East Reading Mass Rapid Transit Route Benefits

East Reading MRT Project Briefing Note

Appendix I Design South-East Response

Report of Design Review Meeting

Figure 7 – East Reading MRT – Proposed Design

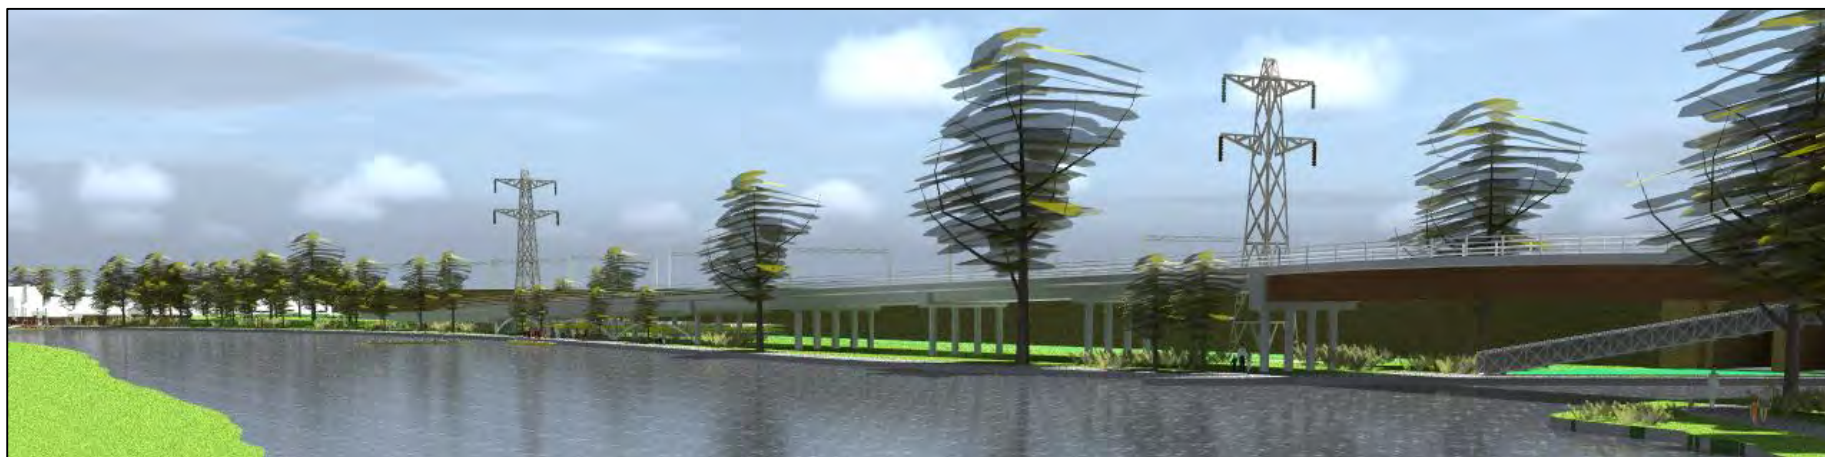
Further to the above, we would be grateful for design advice regarding the proposed bridge and viaduct design shown in *Figure 7* above, specifically relating to the following key questions:

The Panel supported the idea expressed in the material issued for the deck to read as a sinuous element that gently curves in plan and section reflecting the fluid nature of the river and railway line adjacent. This ambition is not currently being supported by the detail of bridge design. A key decision should be whether the raised platform and bridge are read as a continuation of one another, or clearly separated elements. Potential design approaches could include the creation of a continuous minimal 'blade' structure where the platform and bridge would read as a single element with continuous materials used. Structural elements should be minimised wherever possible in this approach, with a predominately steel structure likely to be appropriate to this aesthetic than concrete. Another option could be to create a clearer separation between the raised viaduct and the bridge.

The significance of the listed structure and its curtilage were not fully explored/explained. The Panel were unconvinced that setting the bridge height at 6.7m was preferable to it either being higher (so as not to be visible through the bridge portal to the south) or lower (which would make intermediate connections up/down to the riverside path easier). If part of the significance of the structure is its appearance as a complete 'piece' then a judgement or justification for a particular height, and indeed the bridge's plan position, needs to be made and with reference to agreed key views. The Panel also felt that the possibility of removing the existing 'accommodation bridge', with its function transferred to the new bridge and the narrative history being recorded/presented through interpretation material on the site, had not been explored. Engaging with the fabric of the listed structure in this way might be a means to enhance an appreciation of its significance, and therefore be an opportunity rather than being a risk to the project, as in any case the project will be interacting with the listed structure due to its proximity.
